**Generic design assessment  
UK EPR nuclear power plant design by  
AREVA NP SAS and Electricité de France SA**

**Assessment report  
Aqueous radioactive waste  
disposal and limits**

#### Assessment report – aqueous radioactive waste disposal and limits

Section 2.3 FIGURE 1: OVERALL KER [LRMDS]-SEK [CILWDS]-TER [ExLWDS] DIAGRAM

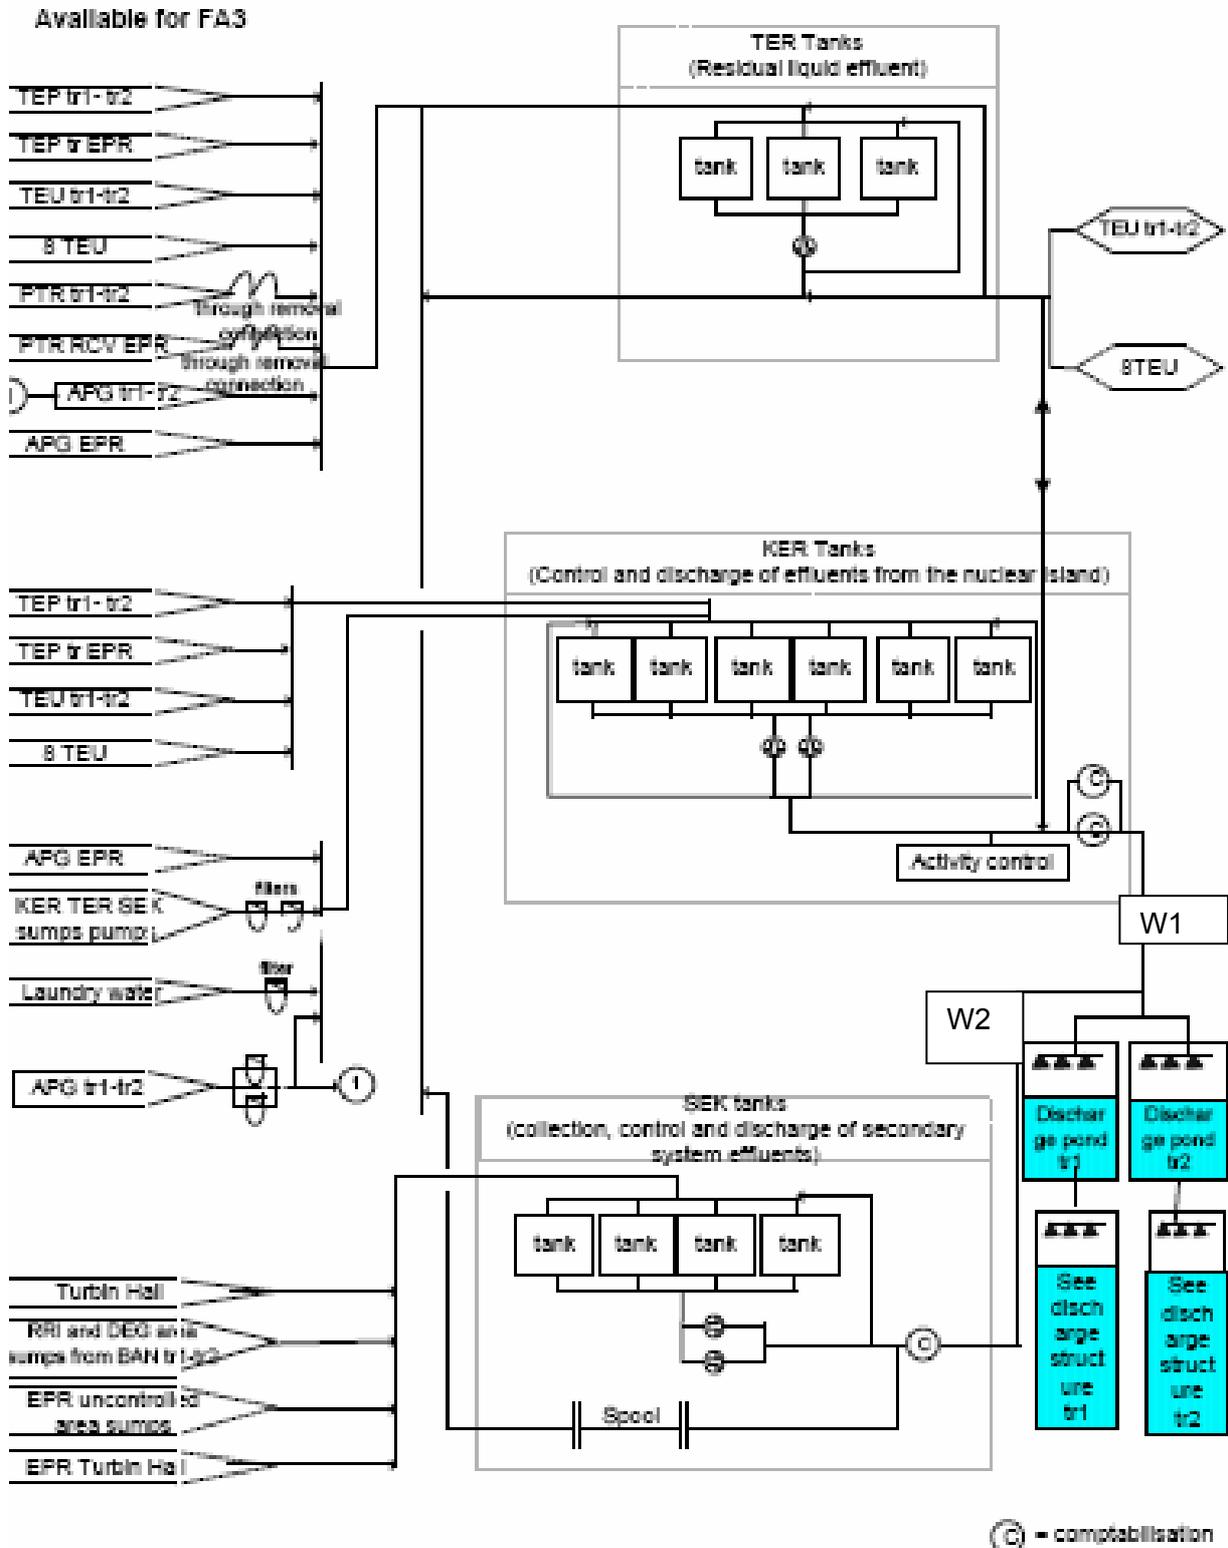
112 We have identified 3 effluent release points for the UK EPR from the example diagram for Flamanville 3 provided in PCERsc6.4s2.3 Figure 1 (page 84)):

- 113 We have allocated references to discharge points, as we would in a permit, as below:
- a) W1 – combined discharge line from 2 sets of tanks:
    - i) from the LRMDS tanks (KER above) in the Liquid radwaste monitoring and discharge system (LRMDS). [6 tanks of 750 m<sup>3</sup>]<sup>#</sup> capacity collect effluent treated by the Liquid Waste Processing System (LWPS).

- b) W2 – discharge line from the CILWDS (SEK above) tanks in the Conventional island liquid waste discharge system (CILWDS). [4 tanks of 750 m<sup>3</sup>]<sup>#</sup> capacity collect effluent from radiologically uncontrolled areas such as the Turbine Hall. In normal operation effluents collected by this system are uncontaminated but may show low levels of tritium in the event of any leaks from the primary to the secondary systems.

Sub-chapter 3.4 - Figure 1: Nature of liquid radioactive discharge

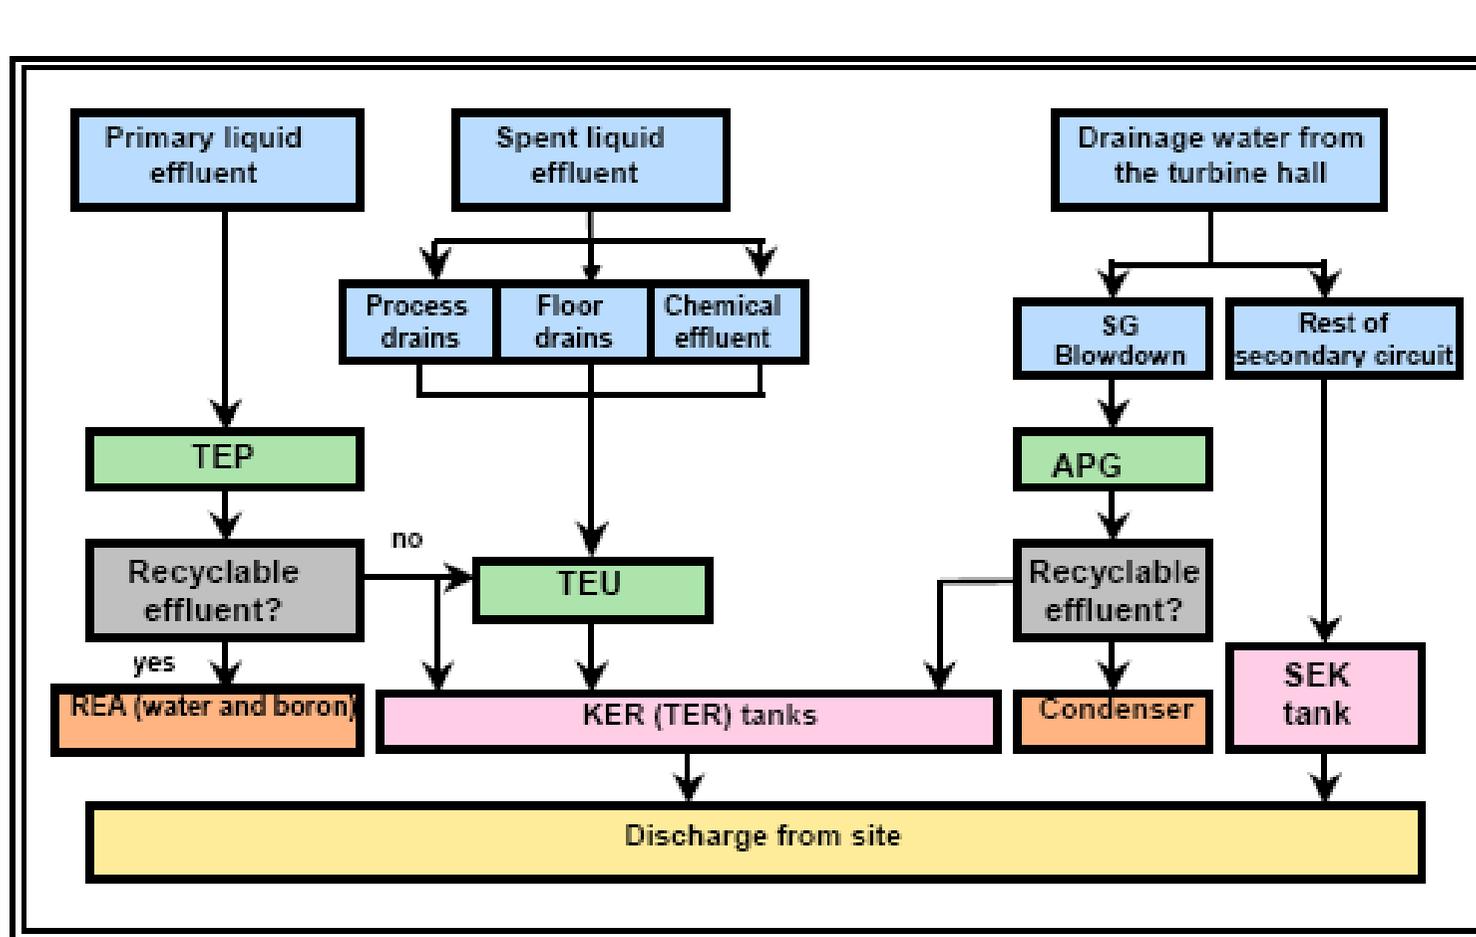
- 48 The PCERsc3.4s5.2.2 (see also Figure 1 reproduced in the Annex of this report) describes three categories of liquid radioactive effluent:
- a) liquid associated with the reactor coolant, not chemically polluted;

- b) spent liquid comprising polluted reactor coolant, chemical effluent and floor drainage;
  - c) drainage water from the Turbine Hall including blowdown from the secondary circuit.

Section 1 FIGURE 1 : OVERALL DIAGRAM FOR NON RECYCLED LIQUID EFFLUENT

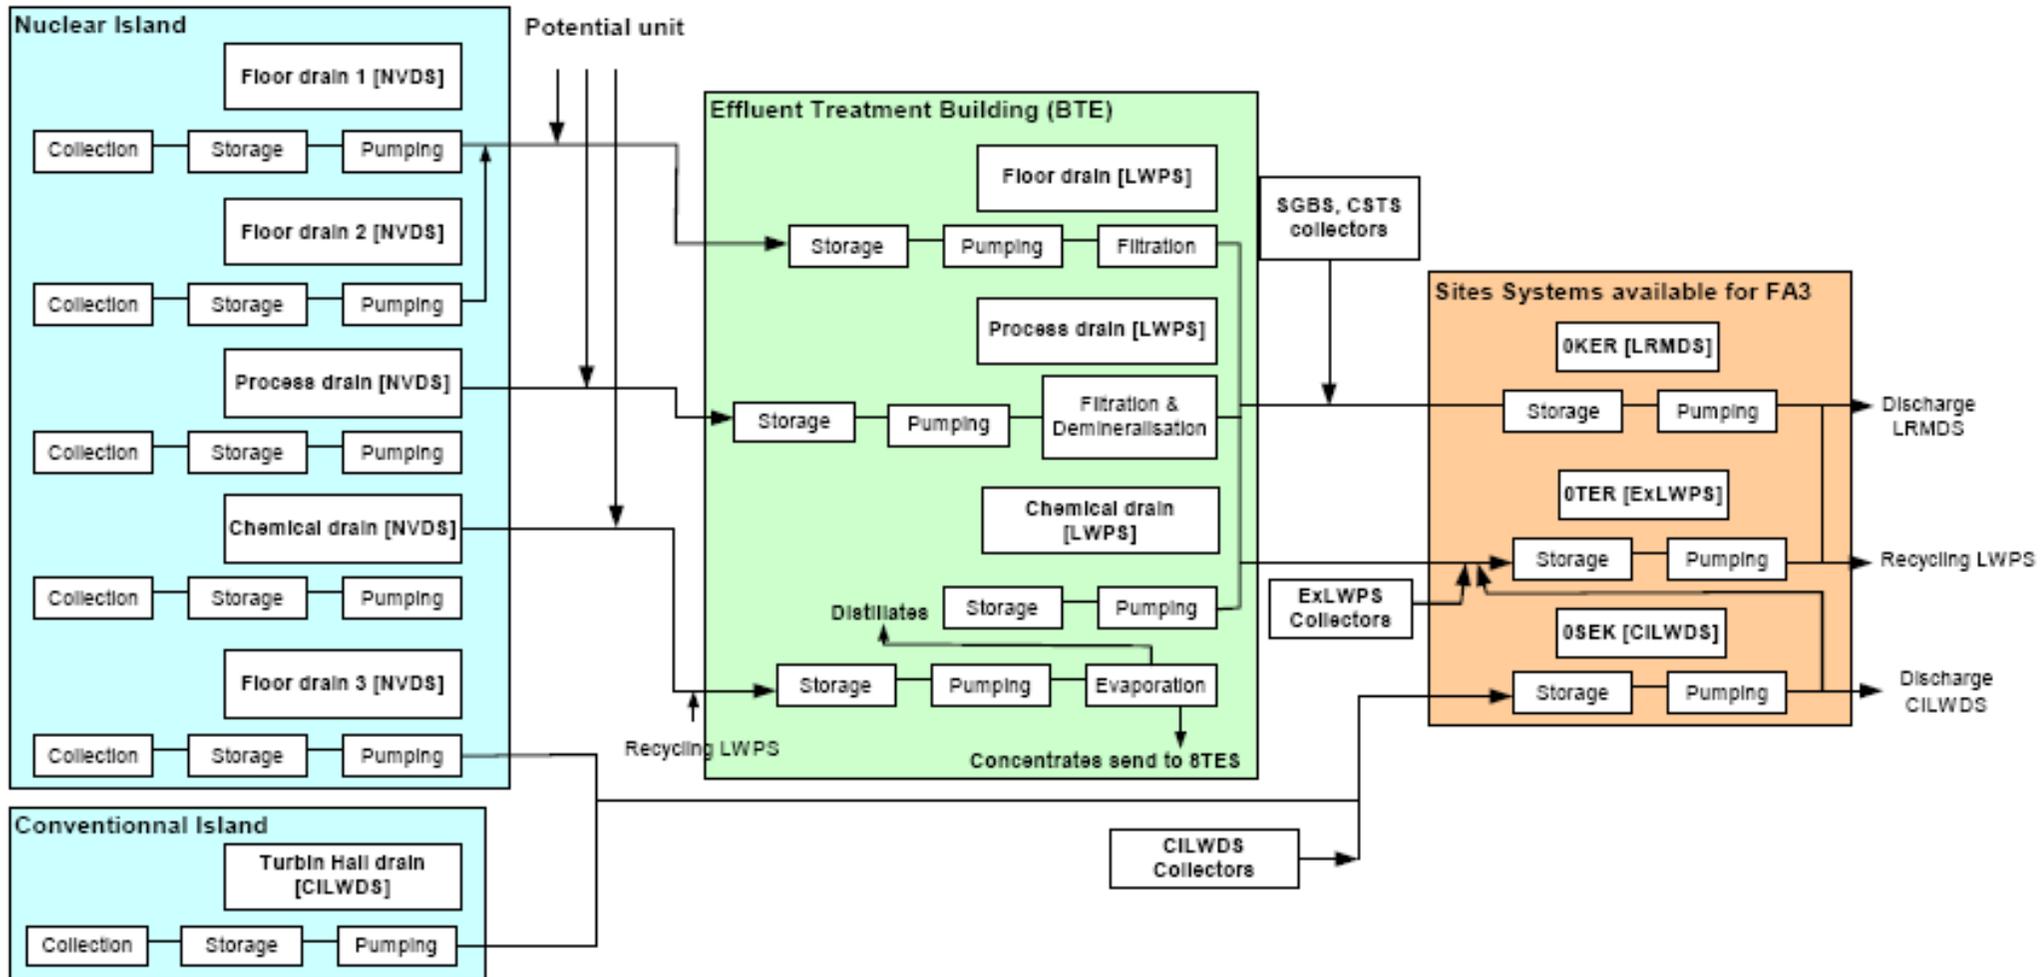
- 52 An overall diagram of the effluent systems is given in PCERsc6.4s1 Figure 1, reproduced in the Annex of this document.
- 53 The UK EPR uses filtration and / or demineralisation and / or evaporation in the LWPS to minimise discharges of liquid radioactive waste. These techniques are specifically targeted at the reduction of fission and activation products and are assessed later in this report. PCERsc6.4s2.1 Figure 2, reproduced in the Annex of this report, shows the principle of routing of effluents:

Figure 5: The Treatment of Non-Recycled Liquid Effluents

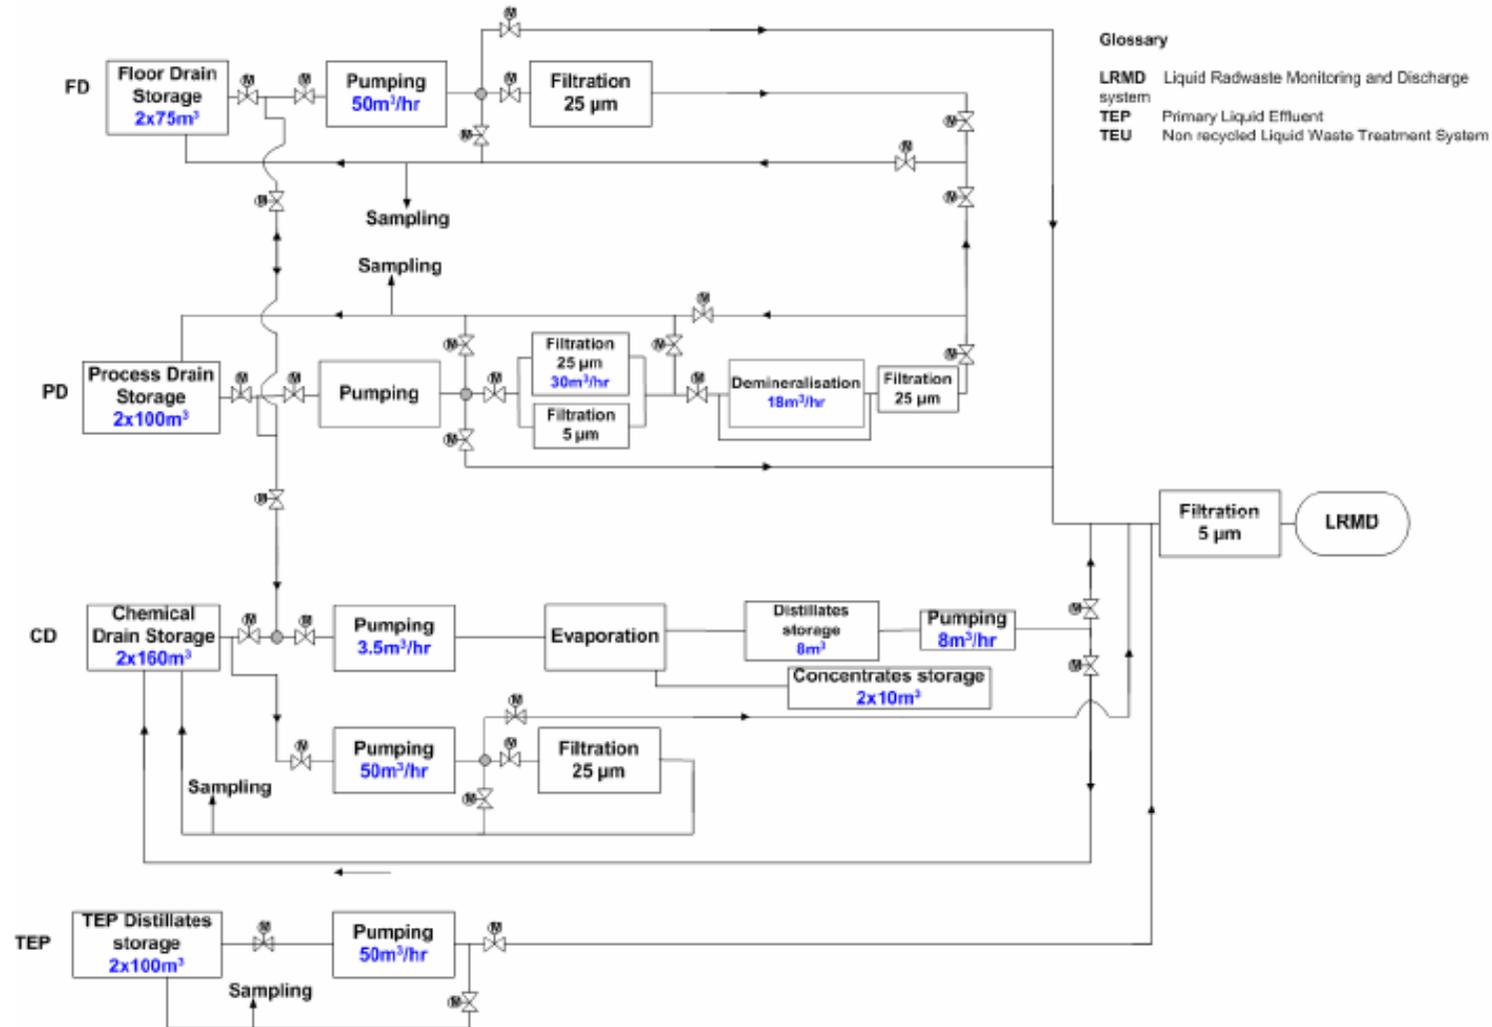
- 96 A diagram of the LWPS is provided as Figure 5 in the IWSp37 (reproduced in the Annex of this report) and more detailed descriptions are in PCERsc6.2s1.1.3.

- a) floor drain system – 25 micron;
  - b) process drain system – 25 followed by 5 micron before demineraliser, 25 micron after (to remove any resin particles);

- c) chemical drain system – 25 micron;
  - d) final filter before discharge tanks – 5 micron.
- 99 All filters are fitted with instruments to measure the pressure difference over the filter element. The pressure will increase as filters are used and retain particles. EDF and AREVA say they will only change filter elements when a set pressure is exceeded. We accept this is BAT to minimise the volume of solid waste arisings from use of filters.
